# AMENDMENT

**TBR 14**

**A1**

**Business TeleCommunications (BTC);  
64 kbit/s digital unrestricted leased line  
with octet integrity (D64U);  
Attachment requirement for terminal equipment interface**

Figure 1

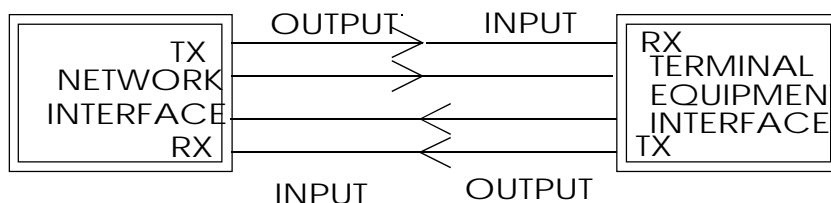
The transmit pair is the output from the terminal equipment interface. The receive pair is the input to the terminal equipment interface, as shown in figure 1. Where the terms "output" and "input" are used without qualification in this TBR, they refer to the terminal equipment interface.
